Subject: Duke Energy Corporation  
Catawba Nuclear Station, Units 1 and 2  
Docket Numbers 50-413 and 50-414  
Proposed Change to Technical Specification (TS) 3.7.9,  
Standby Nuclear Service Water Pond (SNSWP)

On July 26, 2005, the NRC electronically transmitted a Request  
for Additional Information (RAI) to Catawba. The purpose of this  
letter is to reply to this RAI. Attachment 1 to this letter  
contains our reply. The format of the reply is to restate each  
RAI question, followed by our response.

**REPLY TO NRC REQUEST FOR ADDITIONAL INFORMATION**

(updated 07/27/05 by Norman Stambaugh)

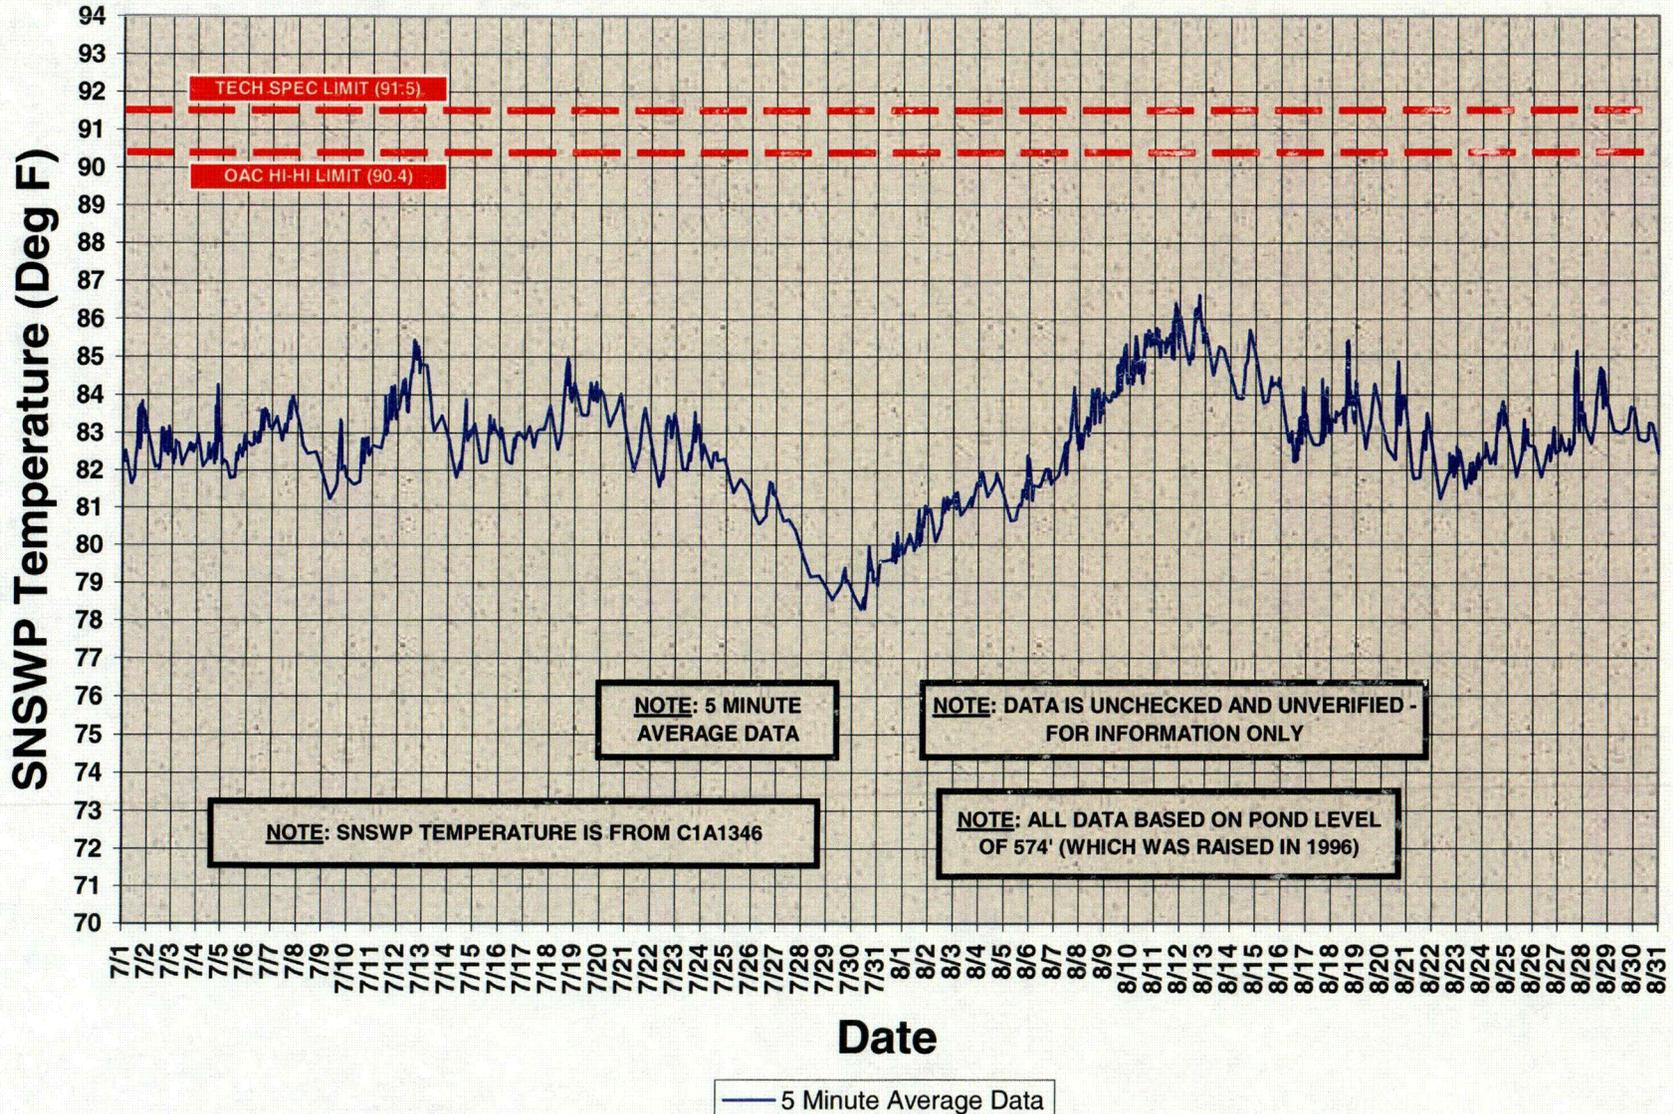
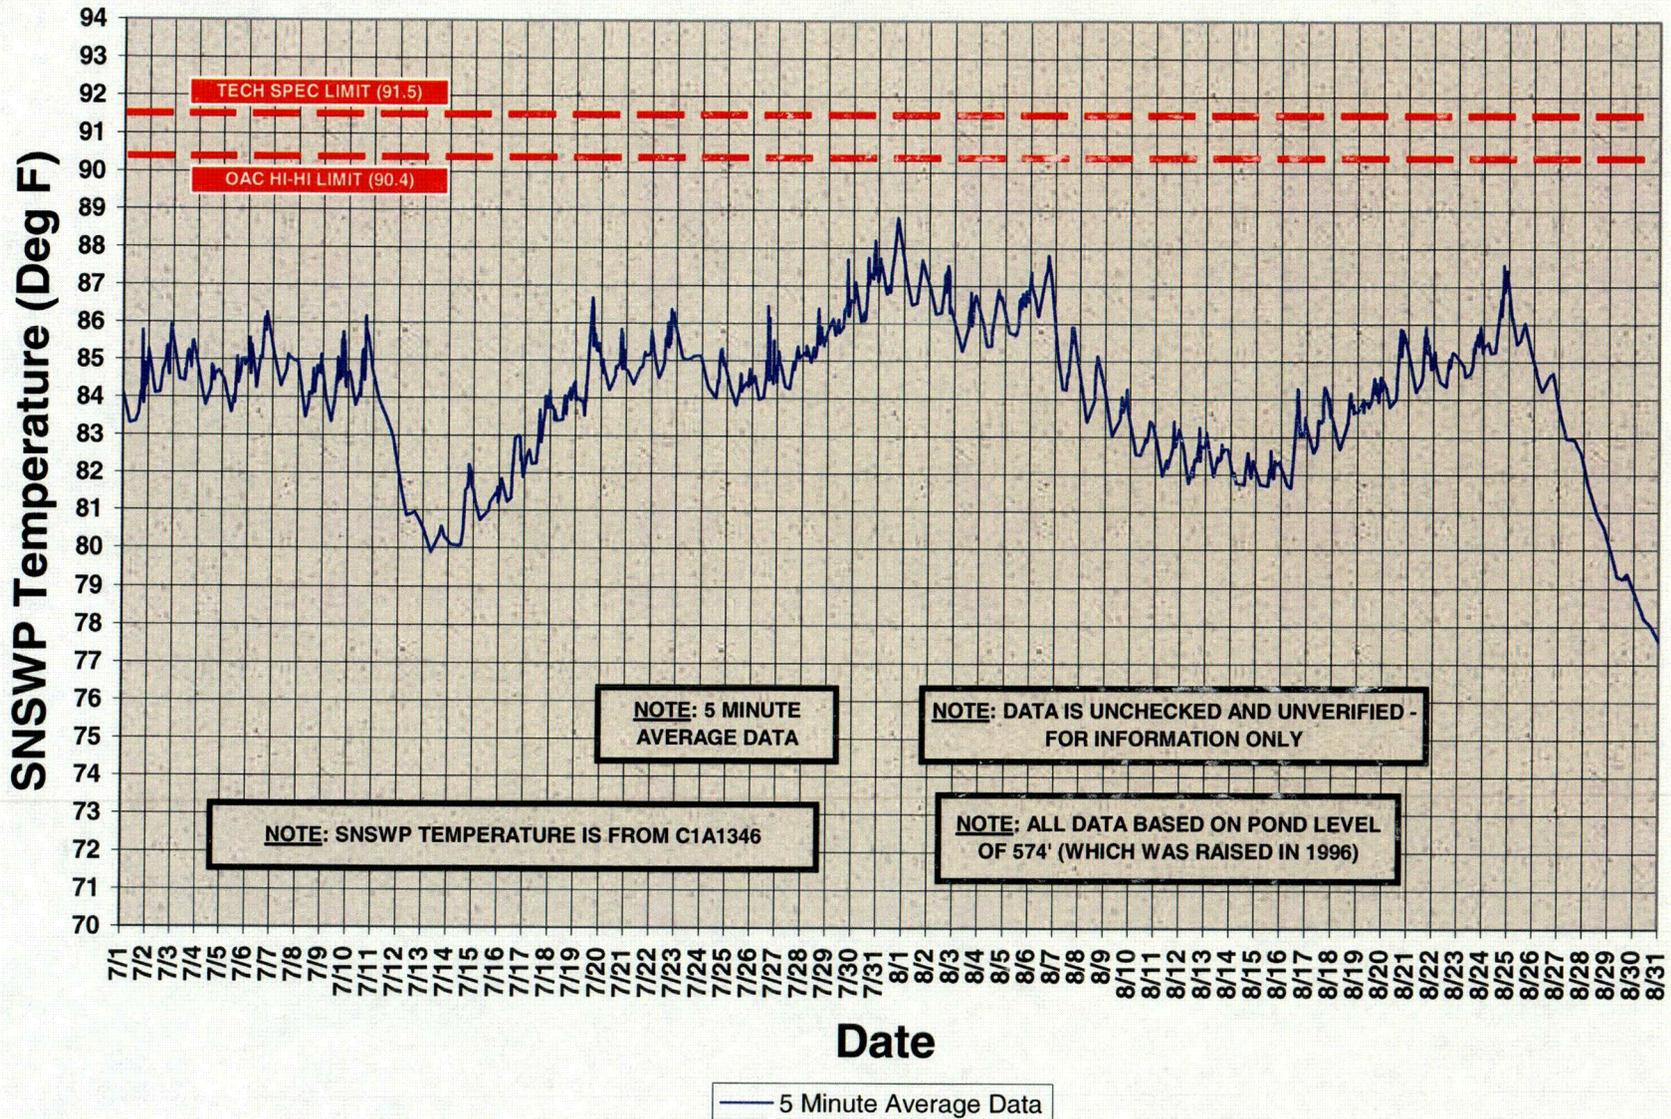
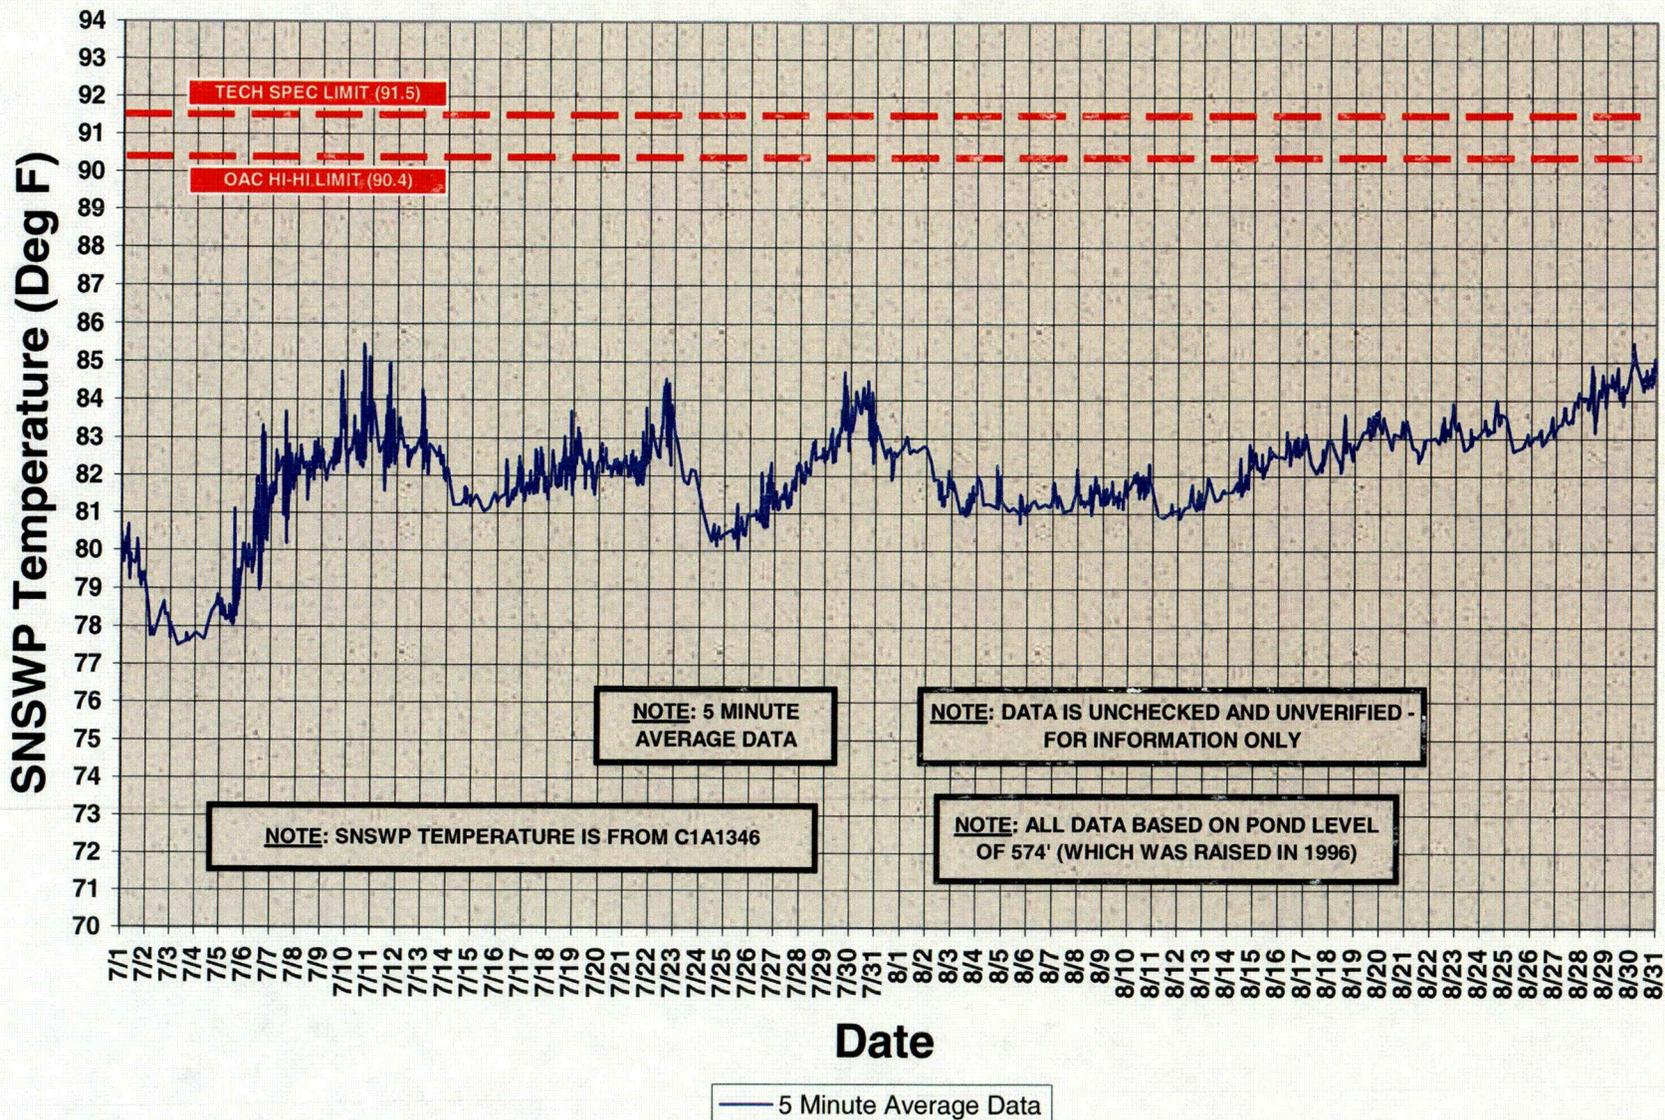
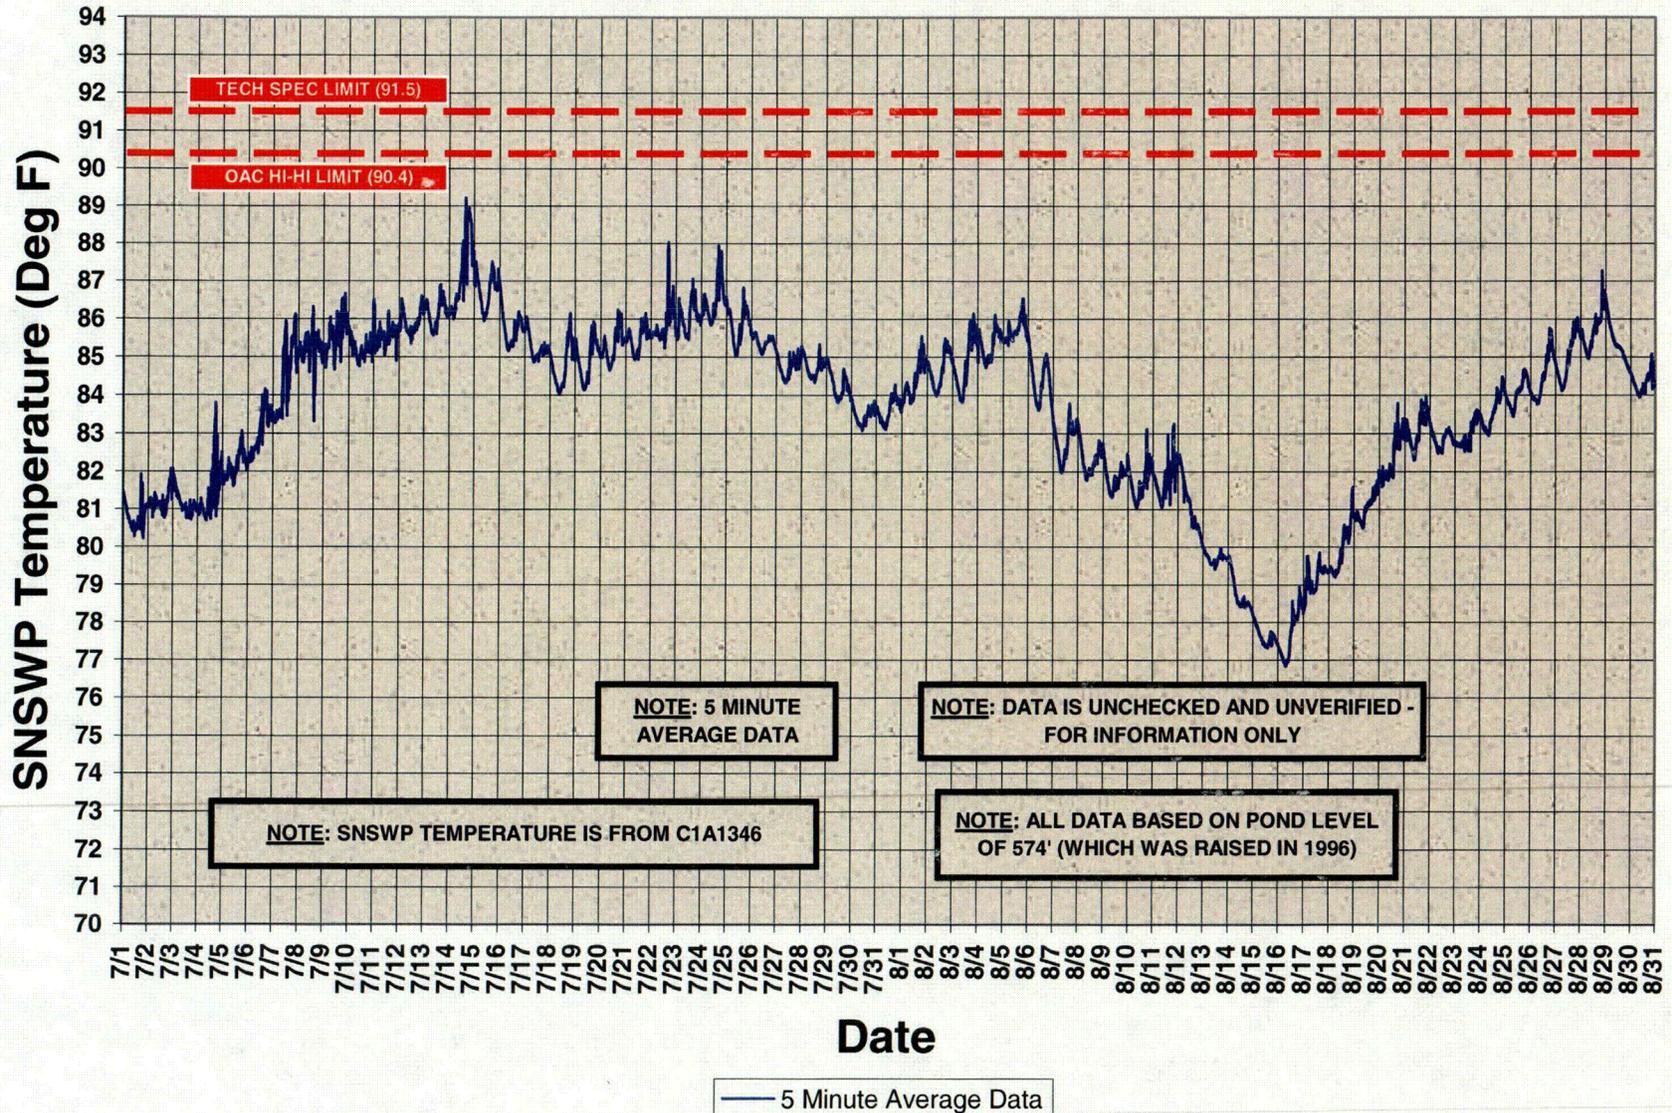
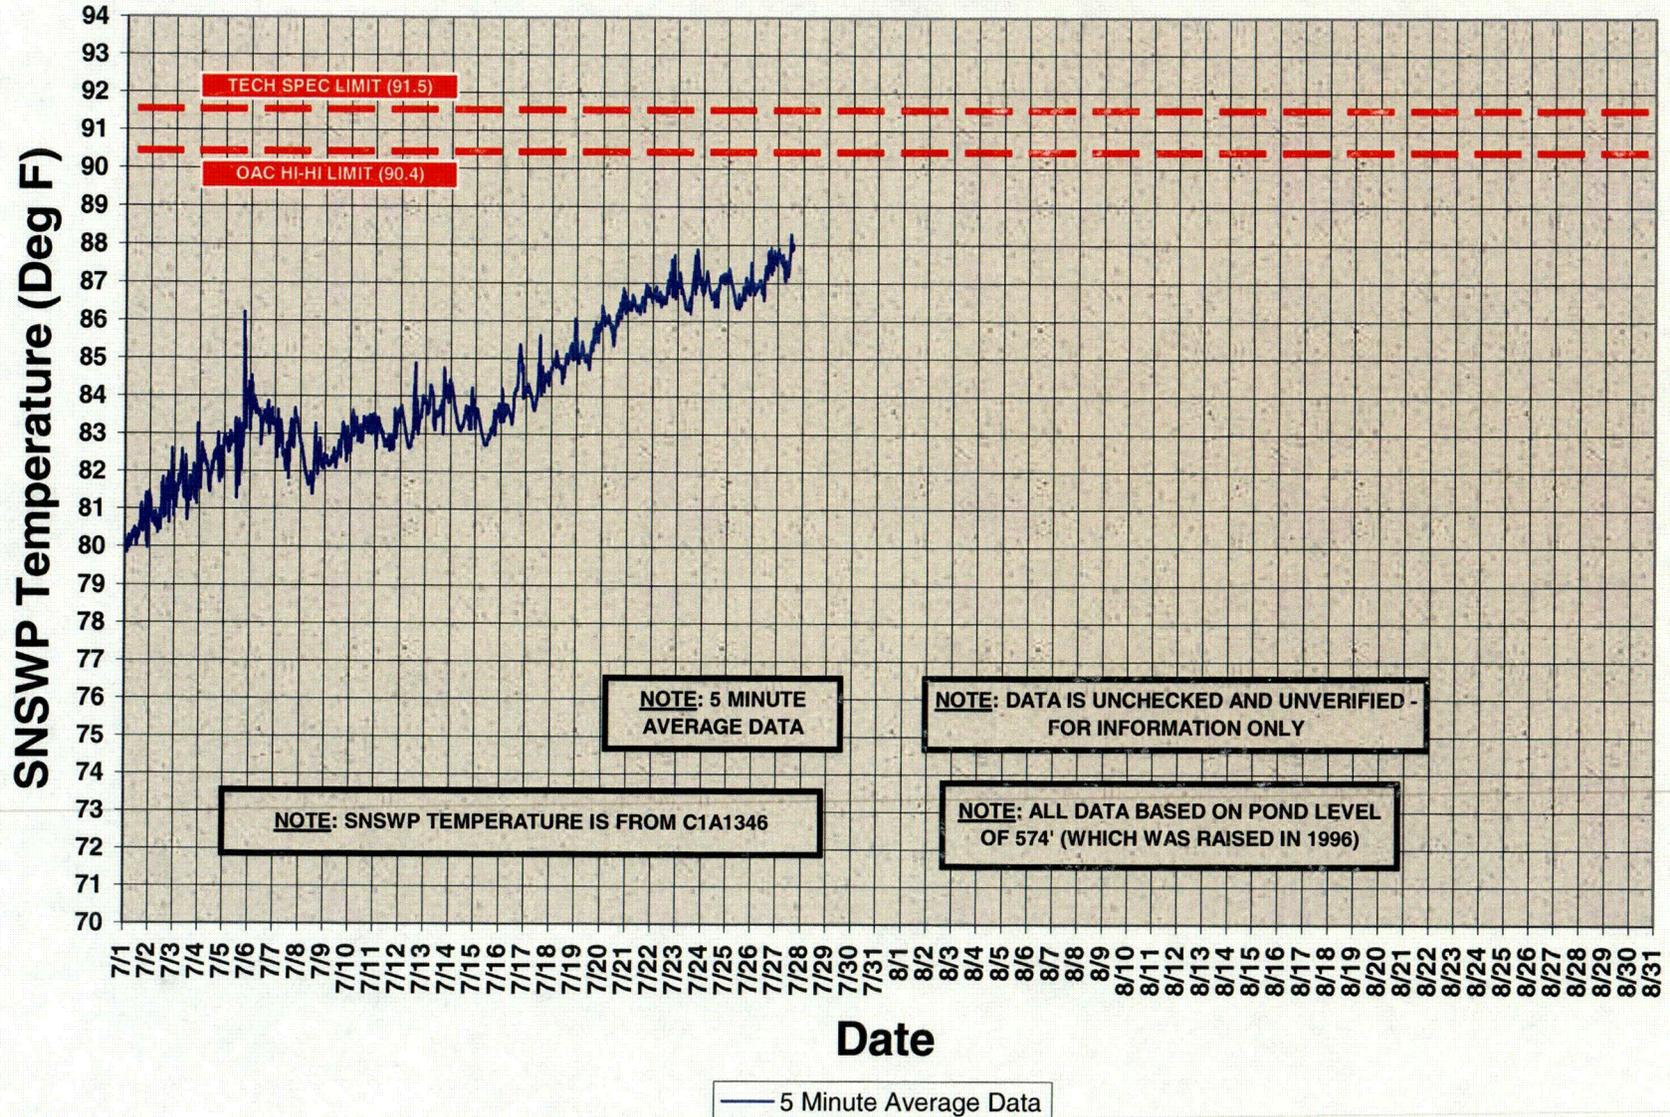
1. Additional information is required in order to demonstrate that the current situation could not have been reasonably anticipated such that an emergency situation pursuant to 10 CFR 50.91(a)(5) exists. Please provide a graphical representation of how the standby nuclear service water pond (SNSWP) temperatures have trended over time (24-hour running average and instantaneous operator/computer values) for the worst two week period of each year since June 1995 to the present, and explain why this information would not cause you to anticipate the elevated SNSWP temperatures that are currently being experienced.

The attached graphs in Enclosure 1 depict how SNSWP temperatures have trended over time during the months of July and August (which includes the worst two-week period of each year for the years 1996 through 2005). There is one graph for each year for 1996 through 2005. The years were chosen to provide a comparison based on the same SNSWP elevation, since elevation can affect measured SNSWP temperature, and elevation was increased to 574 feet in

1996. These graphs utilize 5-minute average data from the Operator Aid Computer (OAC). In addition to graphs for each year, there is also a graph which compares 2005 temperatures with the historical minimum, maximum, and average temperatures for the years 1996 through 2004.

The data in Enclosure 1 indicates short term spikes of up to 89°F during the hot summer months. In the 20 plus years of operating history, there has never been a forced shutdown of a Catawba unit due to SNSWP temperature. Therefore, there was no reason, based on historical data, to anticipate the need for an emergency TS change. However, Catawba did identify the need for additional operating margin in case the historical weather patterns became more challenging. Catawba has been working on the analysis to support this amendment for several months prior to the submittal. Beginning several weeks ago, Catawba began experiencing an extended stretch of hot, humid weather that resulted in an upward trend in SNSWP temperature of approximately 0.4°F per day and increasing Lake Wylie temperatures. Catawba has also historically experienced short term spikes of up to 3°F due to late afternoon rain shower runoff, where the runoff picks up heat from the SNSWP surroundings. Based on the trend, the potential rain runoff concern, and predictions of continued hot and humid weather, Catawba management decided it was prudent to expedite the completion of all required analysis to support raising the SNSWP temperature limit and to submit an emergency TS amendment. In the meantime, Catawba has been aggressively making up to the SNSWP during times of relatively low Lake Wylie inlet temperature in an effort to slow the upward trend in SNSWP temperature. These efforts have slowed the rate of increase of SNSWP temperature. Temperature reached 88.4°F on July 27, 2005. These measures will not be effective indefinitely without a break in the weather. Therefore, continued SNSWP temperature increases over the next few days, and/or a short term temperature spike, could result in exceeding the existing TS limit.
